ADDENDUM NO: 1

Projects: Little Village RAD Modernization and Site Improvements

WROUGHT IRON ON BLOCK WALL

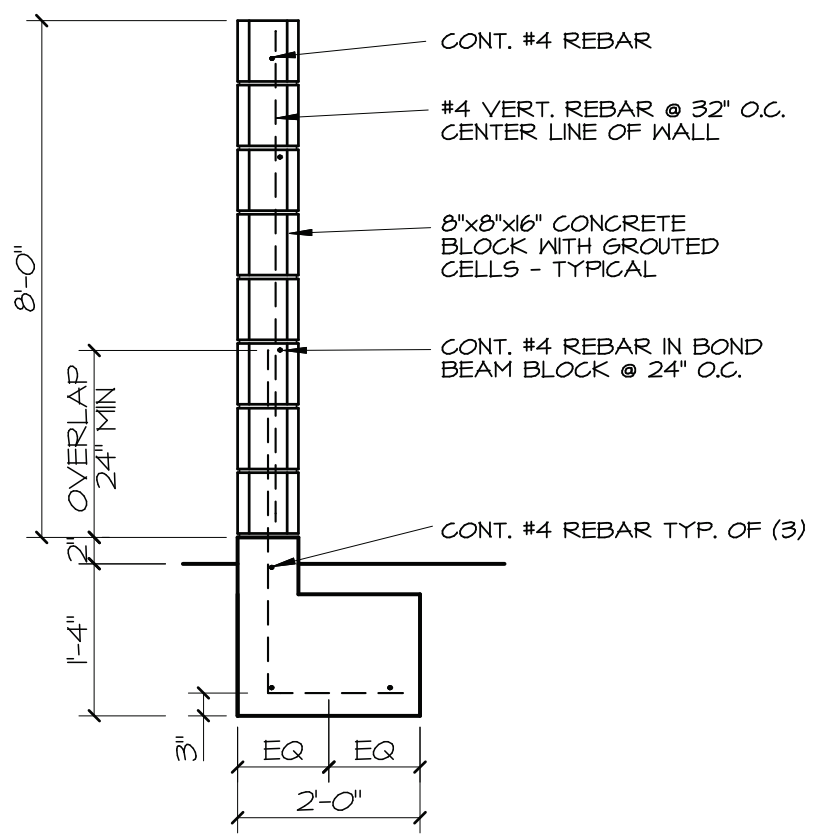
- Item 11: New CMU wall between development and railroad tracks per keynote #6 on SI5-0 shall be 8x8x16 fully grouted block with wrought iron fencing per attached Diagram 1.
